# City of Ottawa

## Main Street Road Safety Audit

FINAL REPORT

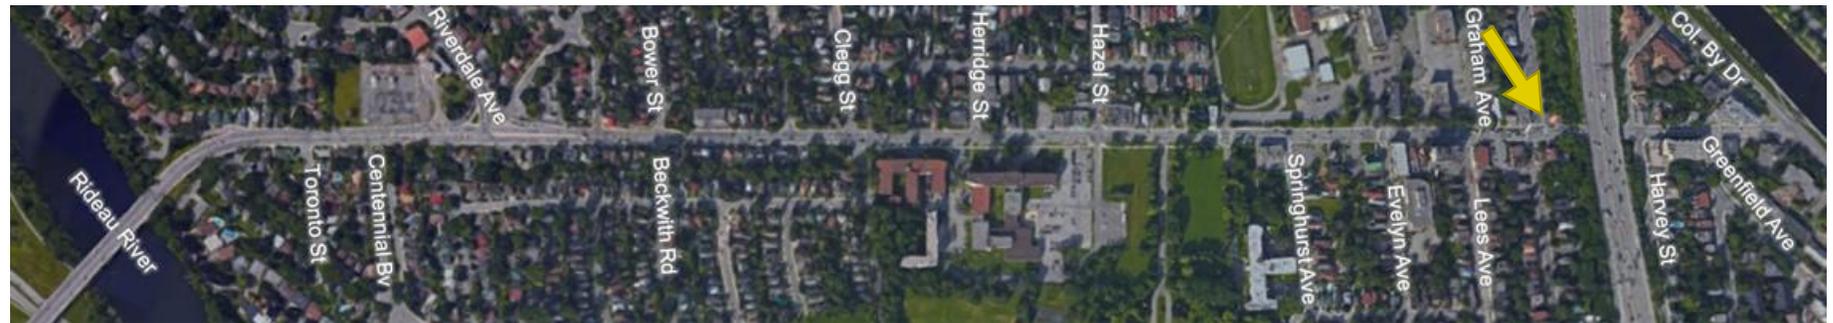
A very short section of cycle track (approximately 10 metres) is provided on the north side of Hawthorne Avenue, immediately west of Main Street. A bus stop is located west of the termination of this cycle track section. Buses were observed encroaching this cycle track with the front overhang when completing a northbound left-turn from Main Street.

Additionally, multiple cyclists were observed not using this cycle track (either riding on the sidewalk or on the roadway). Potential reasons for this are; there is no cycle track on Main Street southbound, and using the cycle track may be uncomfortable for cyclists, as the cycle track is raised and depressed over a short distance.

The cycle track is planned to be extended (further west) with the upcoming Hawthorne Avenue project. The comments above, as well as the comments provided by the Old Ottawa East Community Association, will be forwarded to the City's Project Manager for the Hawthorne Avenue Project, as well as to OC Transpo.

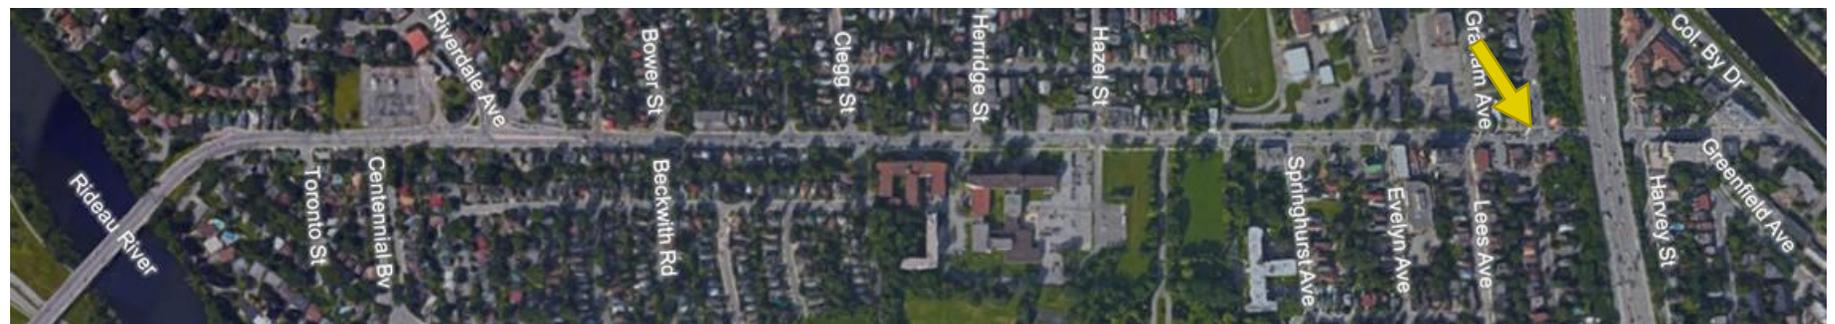
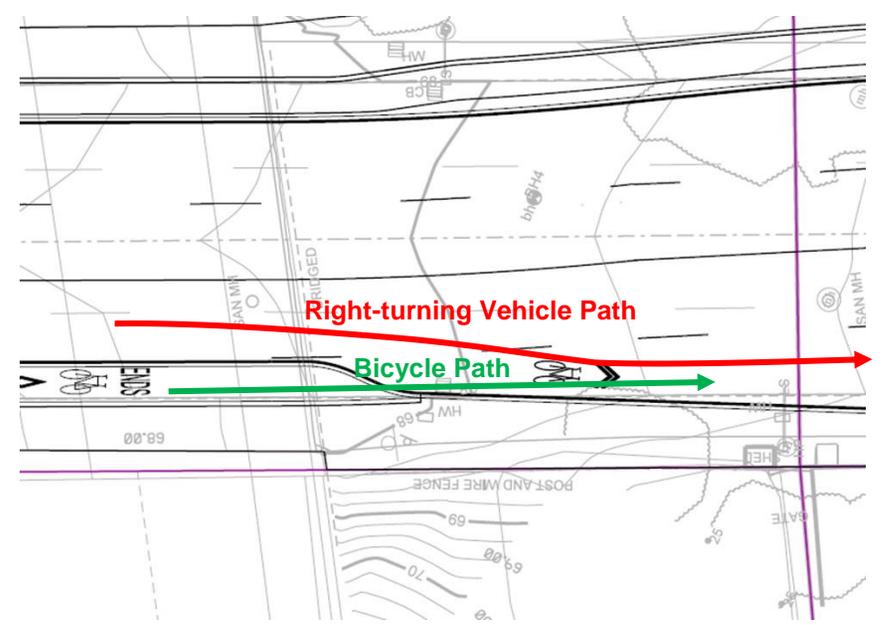
The tight turning radius for the eastbound right-turn at Hawthorne Avenue & Main Street, combined with the short building setback results in a small pedestrian refuge area. This may result in heavy vehicles mounting an occupying the small pedestrian refuge area to complete an eastbound right-turn at this location. The Main Street road sign was observed to be bent, likely as a result of a heavy vehicle encroaching the sidewalk.

Subject to traffic operational analysis, consider providing a curb extension/bulb-out to increase the size of the pedestrian refuge area on the southwest quadrant of the Main/Hawthorne intersection. This will require eliminating either an existing westbound travel lane or the auxiliary eastbound right-turn lane on Hawthorne Avenue.

It should be noted that the feedback received from the Old Ottawa East Community Association indicated that the community does not agree with the comment above with regard to increasing the building setbacks for 62 Hawthorne Avenue at the time of redevelopment. The community Association also does not appear to agree with the recommendation to provide a bulb-out (due to existing geometry). This section is considered a constrained area and therefore there are no countermeasures being considered. **The City will review 3-year collision history (once available) to identify if there are collision trends that could be mitigated.**

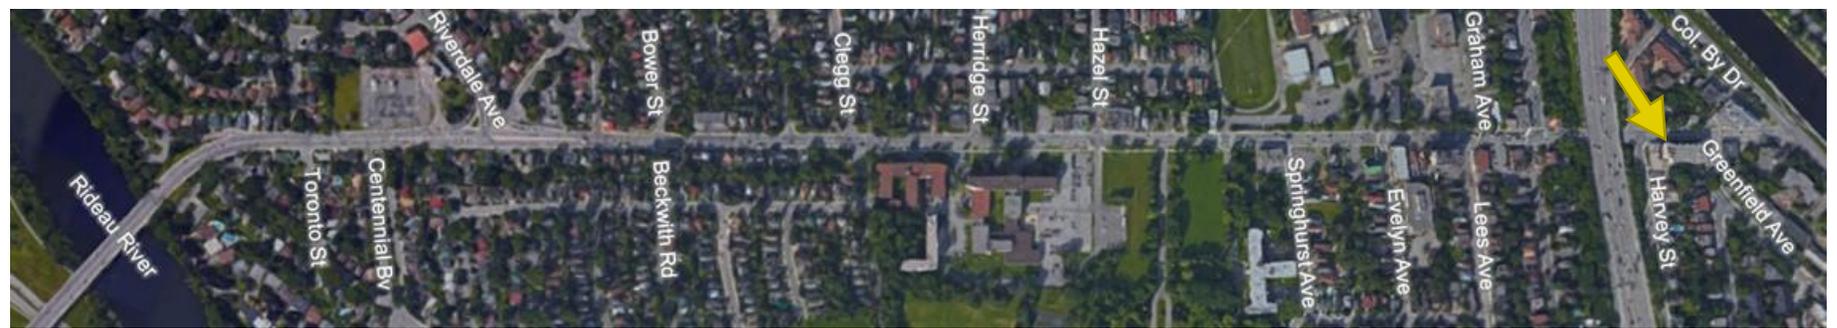
On Main Street, north of Harvey Street, a sign is provided in the northbound direction indicating that motor vehicles and bicycles should move in single file. However, the “sharrow” pavement markings are located on the right side of the lane, near the curb. The curb lane also requires motor vehicles to turn right at the intersection of Main Street & Greenfield Avenue; however, cyclists can proceed through the intersection from the curb lane (e.g. the “sharrows” continue north of Greenfield Avenue). This can create conflicts between right-turning motor vehicles and through bicycles.

Additionally, the pavement at this location was also noted to be in relatively poor conditions (e.g. pot holes) and given the sidewalk surface treatment is asphalt, cyclists were typically found riding on the sidewalk (i.e. because the sidewalk is not concrete, it looks like a cycle track).

Relocate sharrows to the centre of the lane. It should be noted that this lane is approximately 3.2 metres wide, which makes it a narrow lane according to Ontario Traffic Manual. In these cases, sharrows should be painted at the centre of the travel lane. The “sharrows” should also be carefully positioned in order to not interfere with the existing right-turn arrow pavement markings.

**Finding #25: Absence of Bicycle Crossing Facilities / Guidance at North End of Study Area – Severity Rating: Extreme**

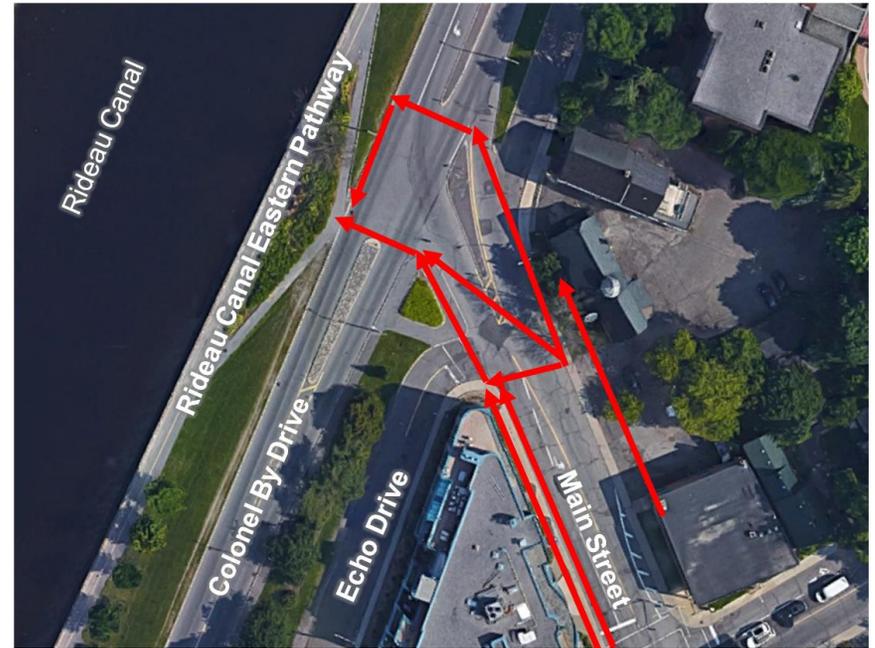
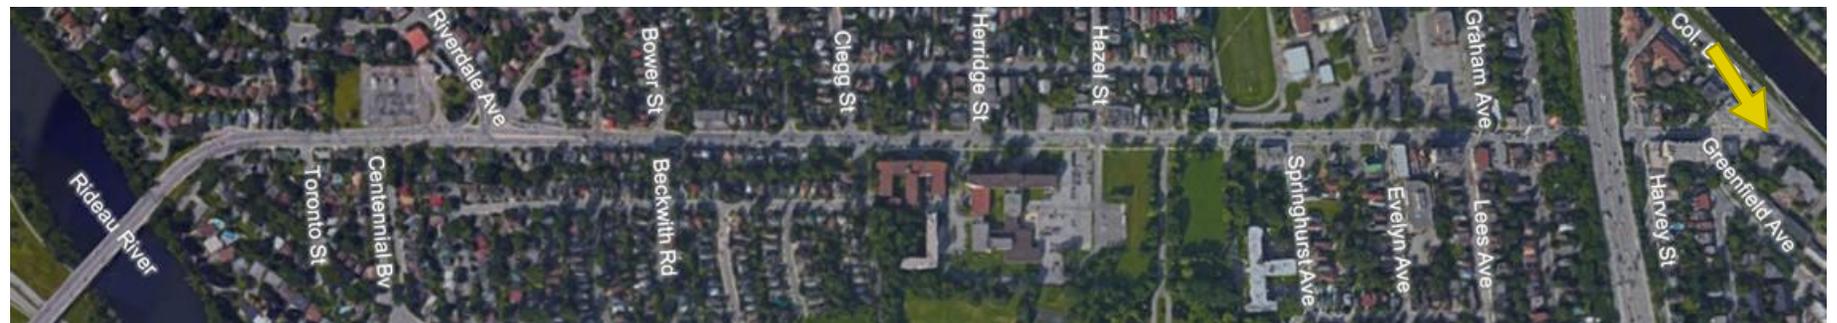
The Rideau Canal Eastern Pathway is located across from Colonel By Drive, and is expected to be used by cyclists. However, there is no guidance or crossing facilities to indicate where cyclists should cross. As a result, several cyclists were observed riding on the sidewalks on Main Street, including in the opposite direction of traffic (e.g. riding northbound on the west sidewalk or on the roadway). The figure illustrates observed northbound routes that cyclists used to cross Colonel By Drive, some of which exposed them to motor vehicle traffic.

Consider reviewing the intersection configuration to reduce its complexity and provide a safe and convenient connection between Main Street and the Rideau Canal Eastern Pathway.

A possible solution is to provide separate north and south cross-ride crossings that provide direction connections to/from the Rideau Canal Eastern Pathway, as opposed to a single access/egress point. However, given the substantial complexity of this intersection, a more detailed study is recommended to determine the most adequate solution. This may include reviewing operational impacts of potential modifications.

Access to the Rideau Canal Eastern Pathway will be considered during the Greenfield reconstruction project, depending on funding and NCC approval.
